Project
**East West Rail
(Western Section)
Phase 2**

Drawing Title
**PASSING PLACE A3_P_6
GENERAL ARRANGEMENT**

Stage 2 Road safety audit response report

Offline Highways Passing Places – Package 2 – Oxfordshire (A3 Marsh Gibbon – Compound Access)

Drawing Title
PASSING PLACE A3_P_6 CROSS-SECTIONS

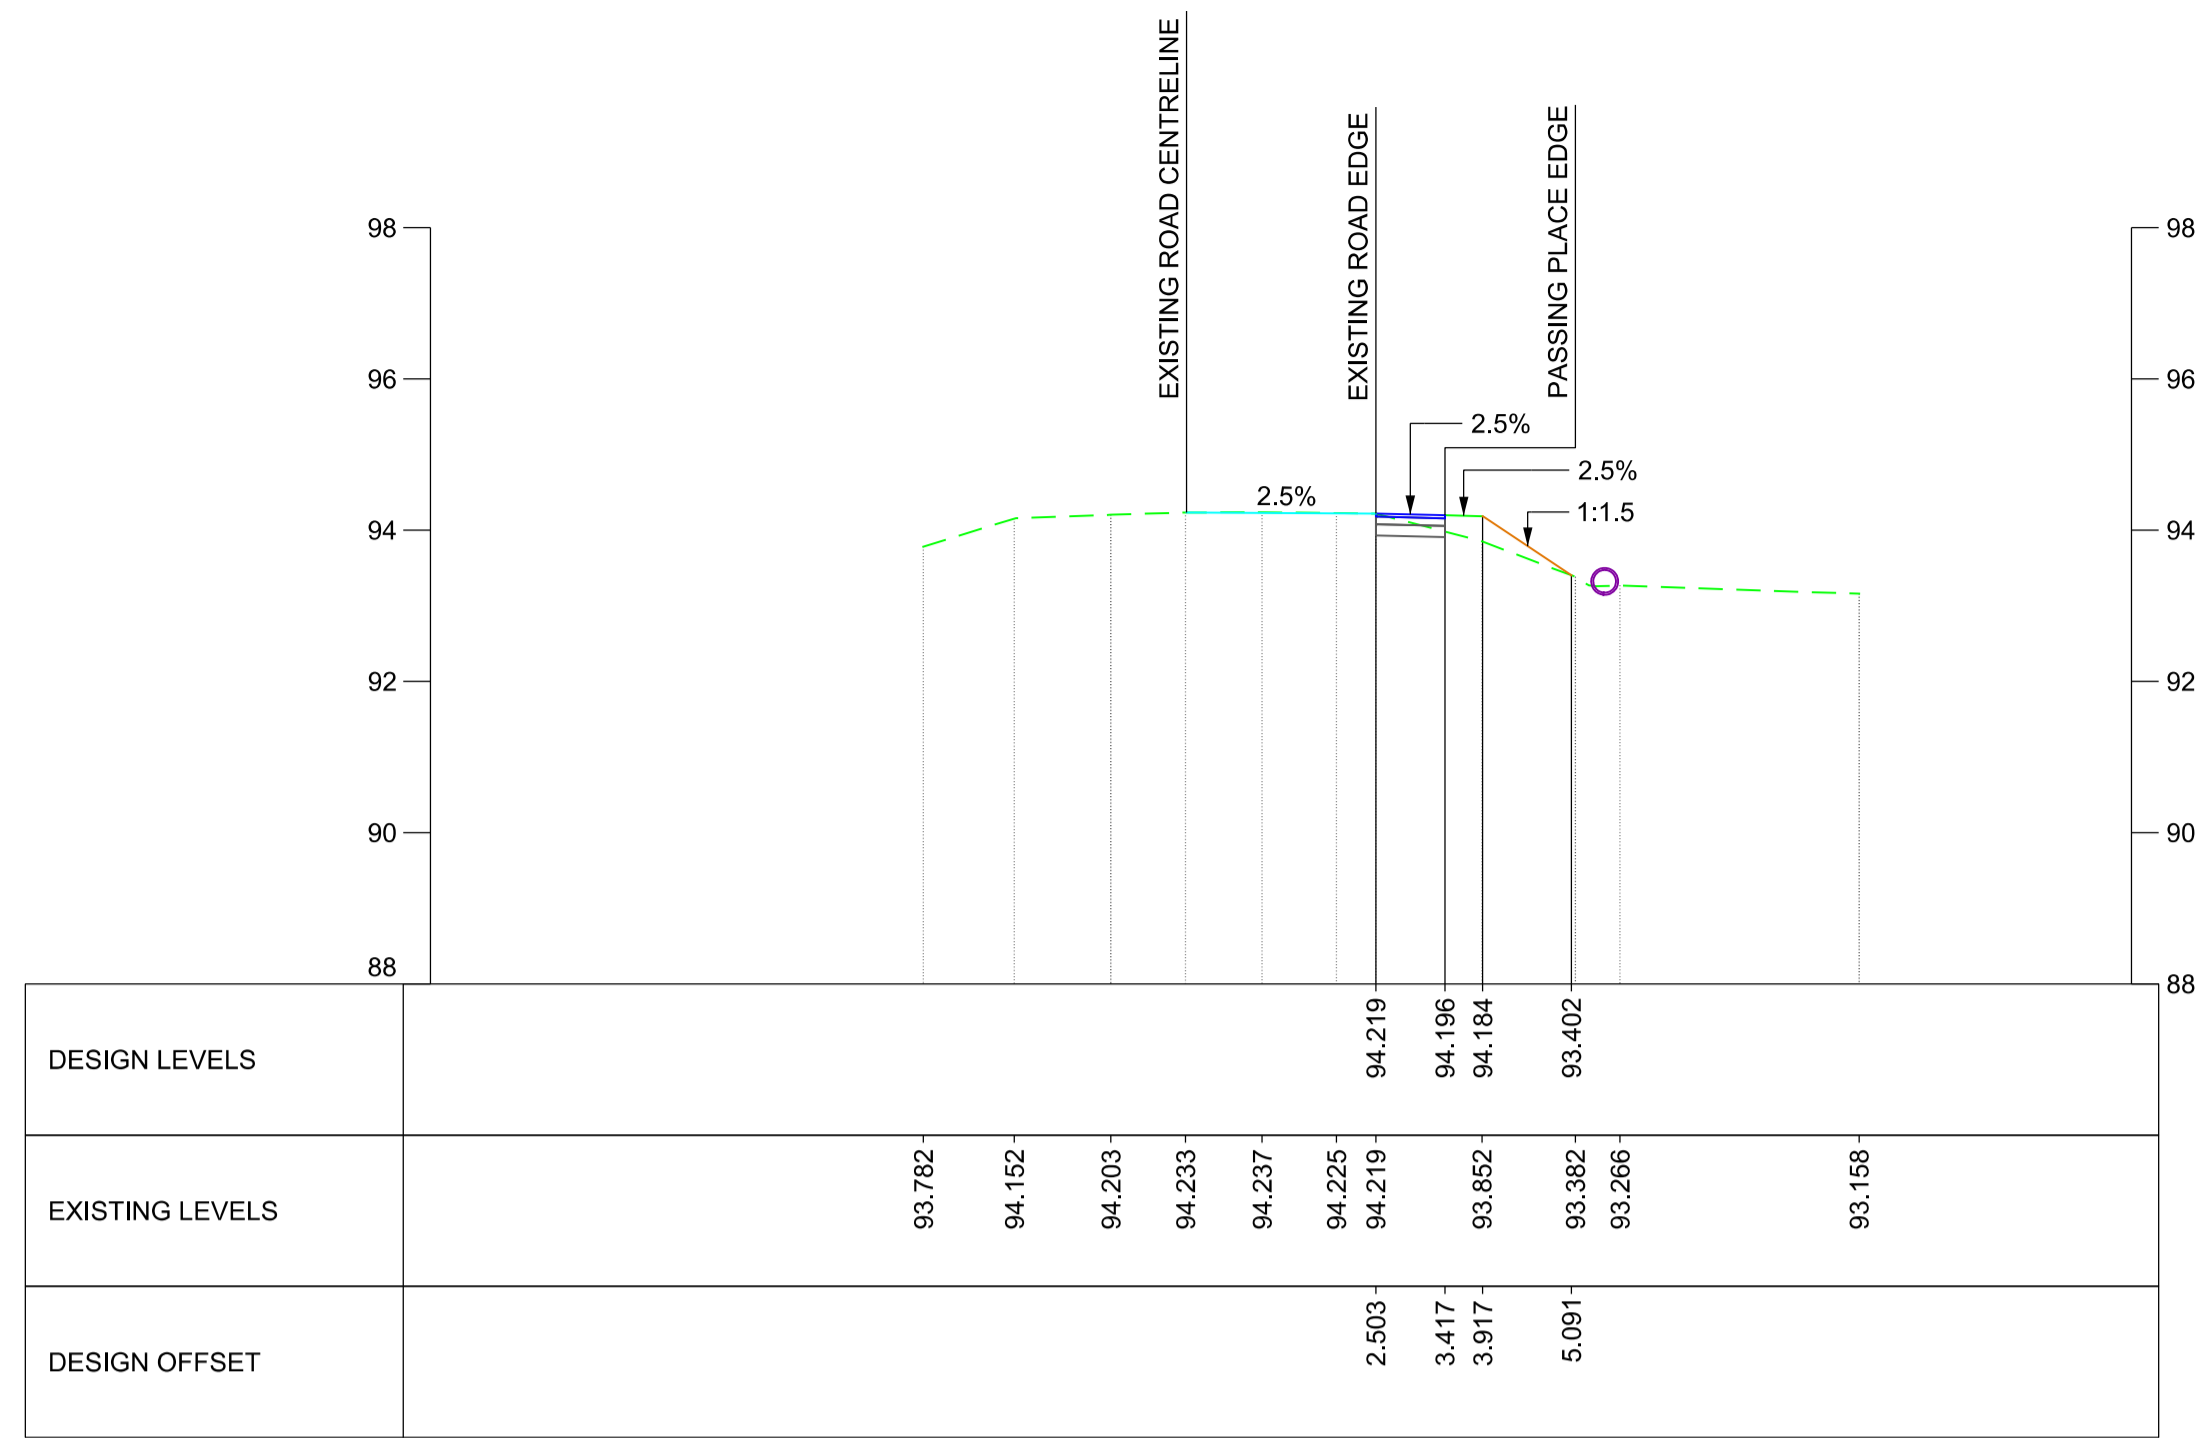
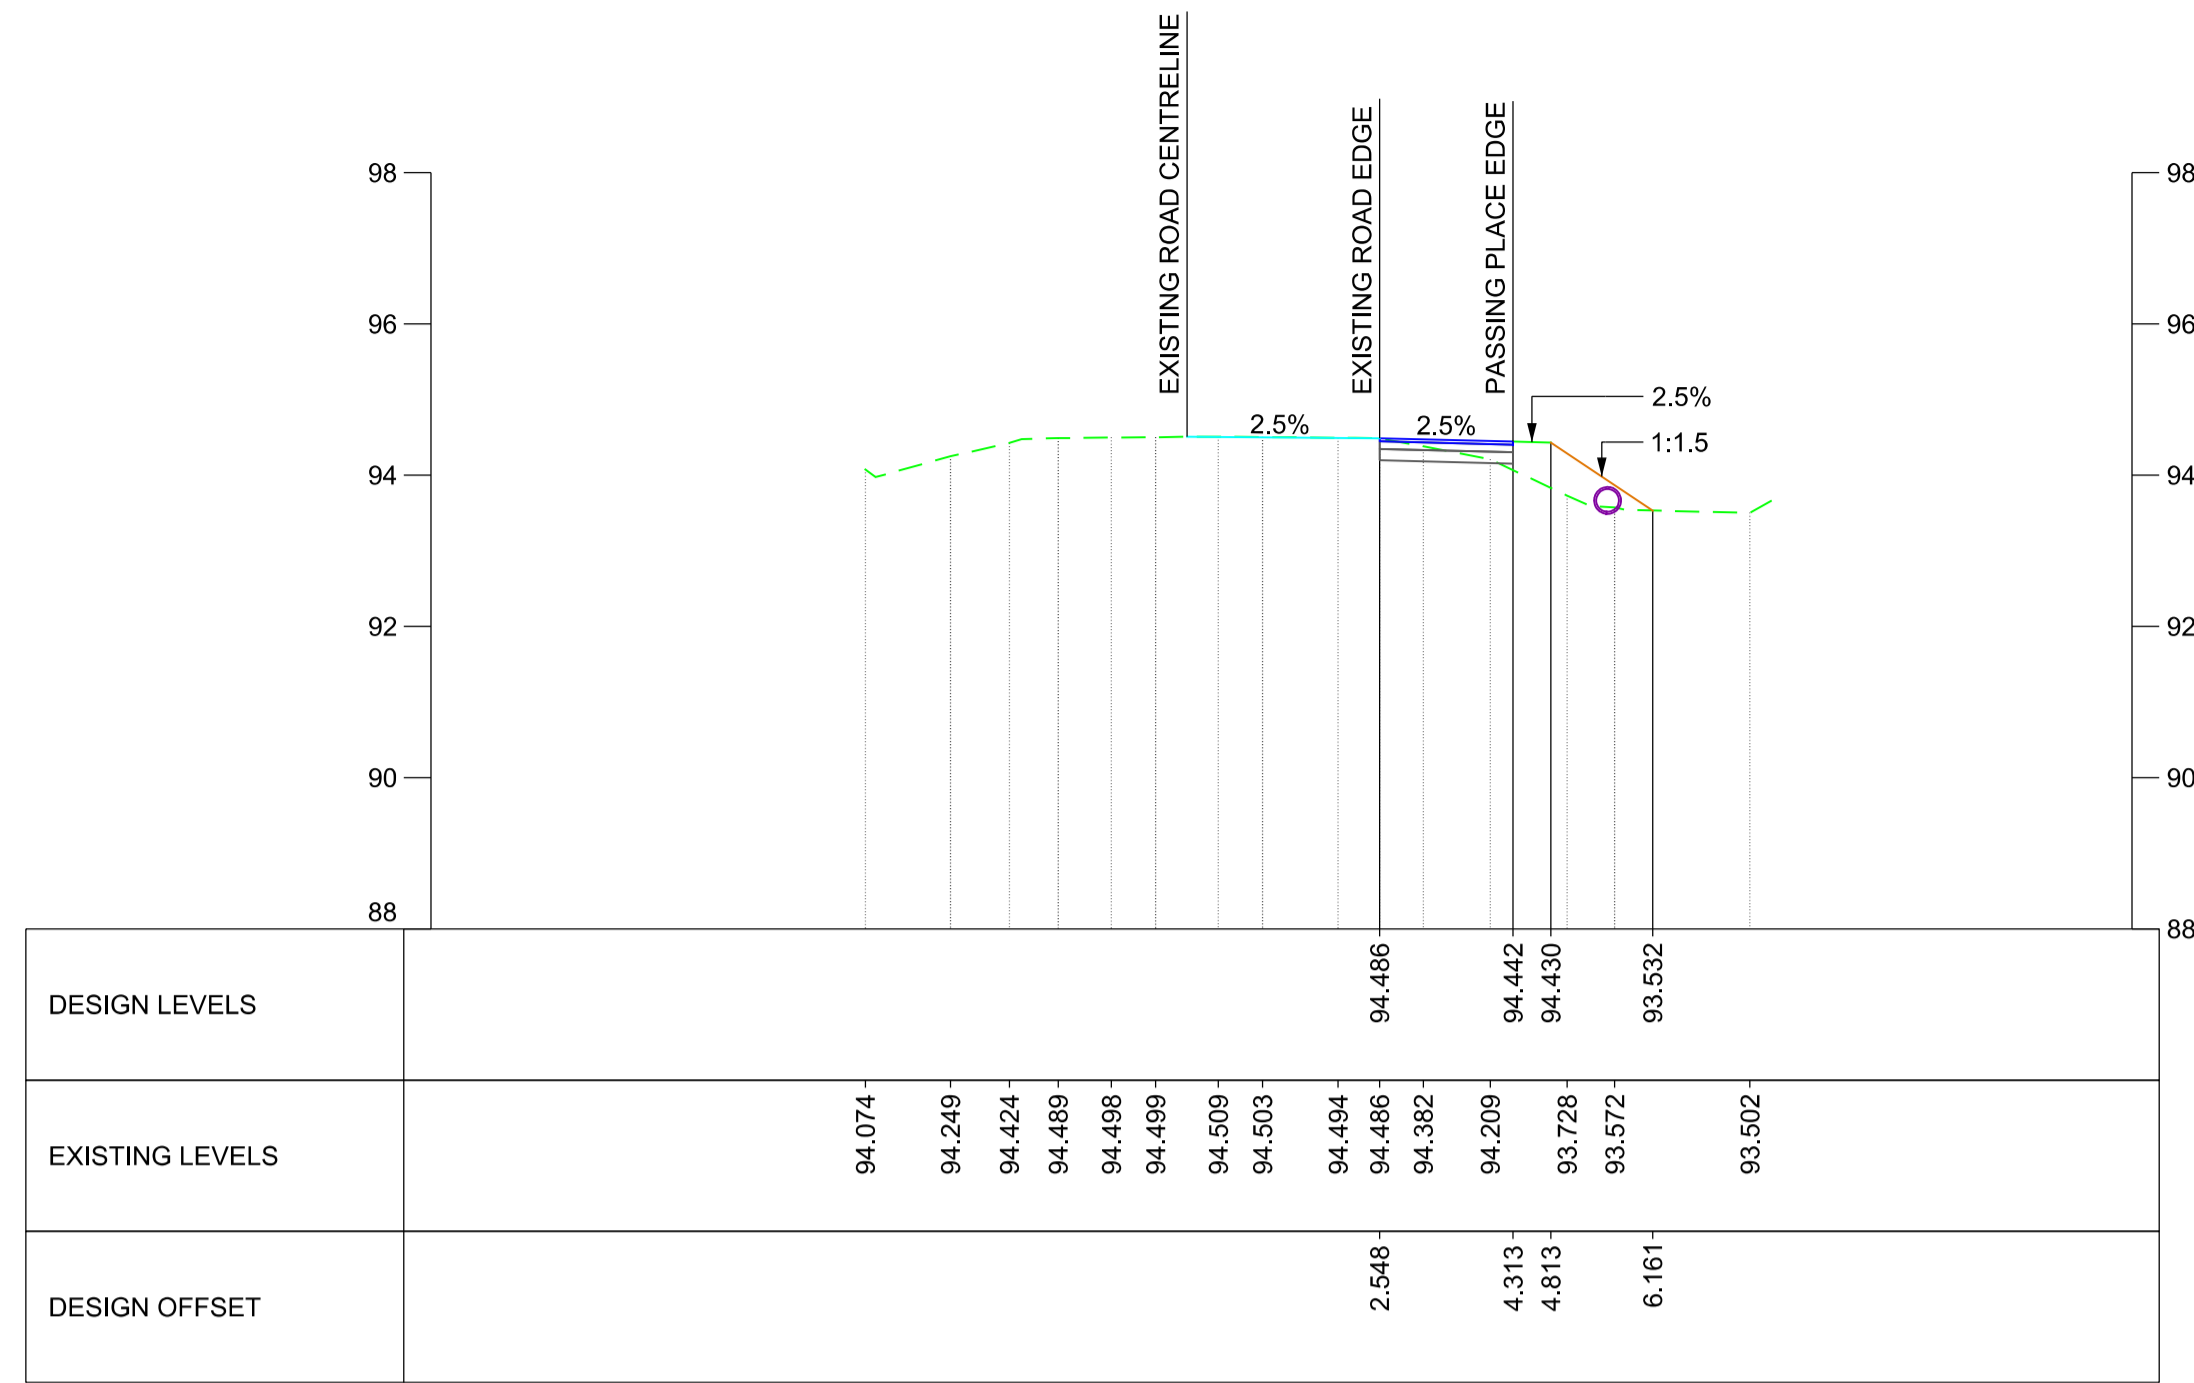
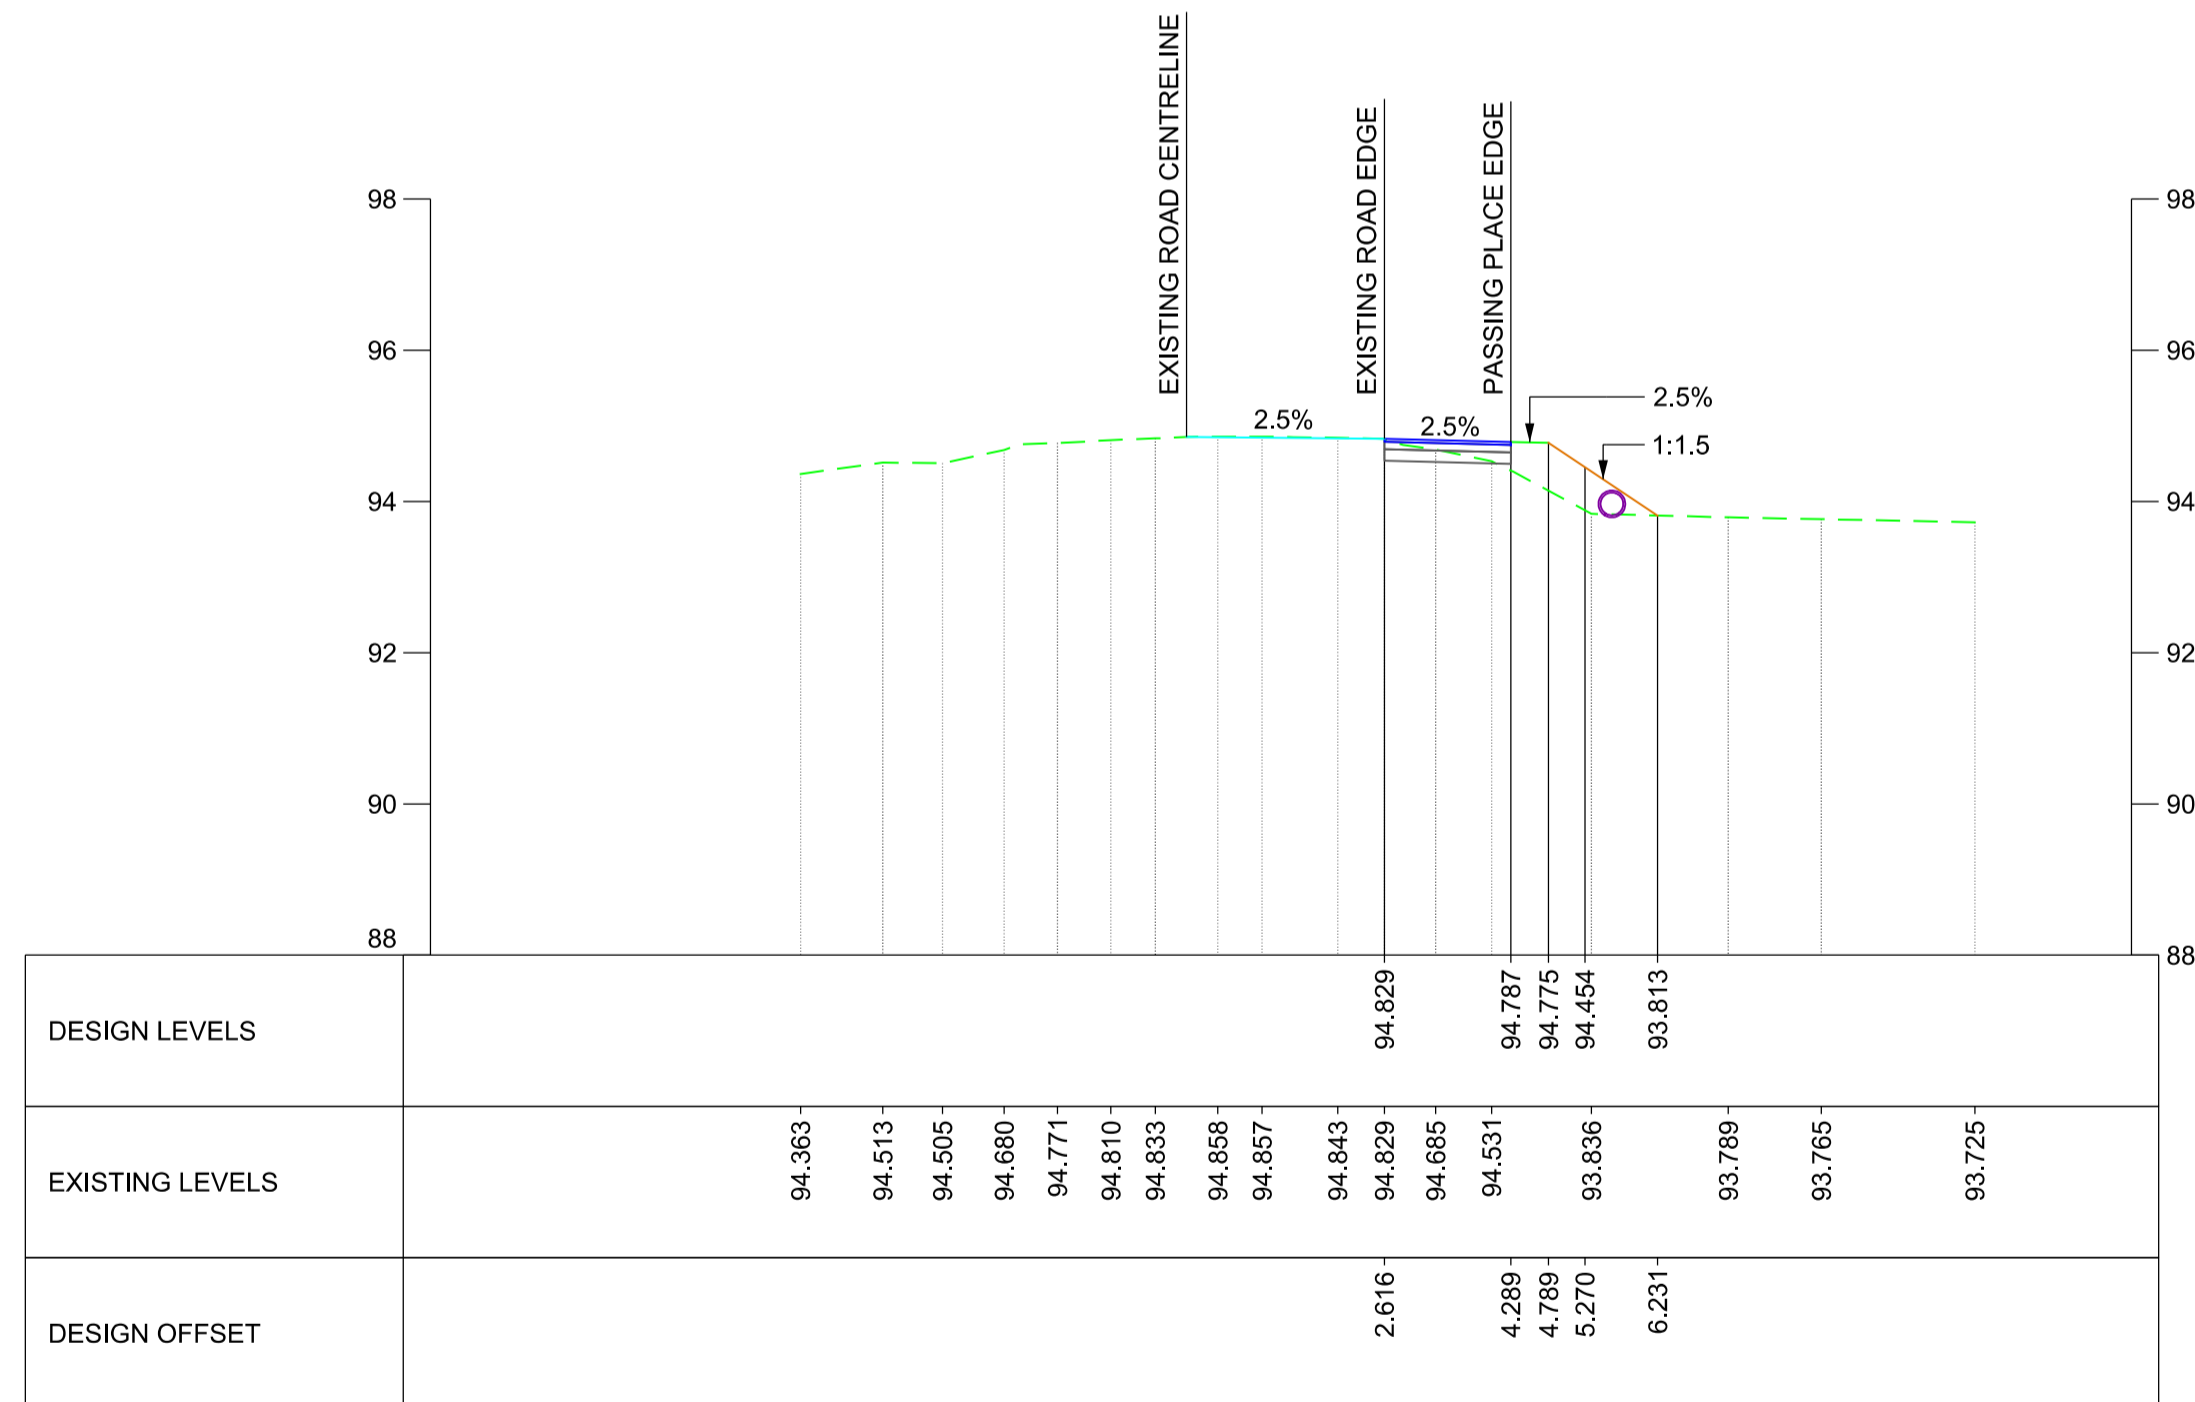
Location: Passing Places A2-P-2, A3-P-2, A3-P-3, A3-P-4, A3-P-5, A3-P-6, A3-P-7, A3-P-8, A3-P-9 and A3-P-10.

Passing places are proposed in positions where vegetation may restrict drivers' visibility of the route and the visibility of vehicles using the passing places. With this limitation, drivers of construction vehicles may not be aware that they should wait and might proceed, increasing the risk of side swipe collisions, or the risk of vehicles leaving the carriageway

on narrower sections of carriageway. Additionally, drivers of approaching vehicles may not anticipate the construction vehicle leaving the passing place, leading to side swipe or head on collisions.

The existing vegetation should be cut back to ensure clear visibility to all traffic signs and to keep the carriageway clear from obstructions.

2.5	<p>Passing Places A2-P-2, A3-P-2, A3-P-3, A3-P-4, A3-P-5, A3-P-6, A3-P-7, A3-P-8, A3-P-9 and A3-P-10. Unnamed Road (towards Mill Road) and Unnamed Road.</p>	<p>Driver visibility reduced by vegetation Passing places are proposed in positions where vegetation may restrict drivers' visibility of the route and the visibility of vehicles using the passing places. With this limitation, drivers of construction vehicles may not be aware that they should wait and might proceed, increasing the risk of side swipe collisions, or the risk of vehicles leaving the carriageway on narrower sections of carriageway. Additionally, drivers of approaching vehicles may not anticipate the construction vehicle leaving the passing place, leading to side swipe or head on collisions. There is further risk that existing vegetation will encroach into the carriageway increasing the risk of damage to vehicles and HGVs being pushed towards oncoming traffic.</p>	<p>The existing vegetation should be cut back to ensure clear visibility to all traffic signs and to keep the carriageway clear from obstructions.</p>	<p>Accept the RSA problem and recommendation made by the RSA team. The site clearance drawings include vegetation clearance to achieve required visibility and signage strategy drawings likewise include this provision.</p>	Accepted	Proceed as Design Team Response
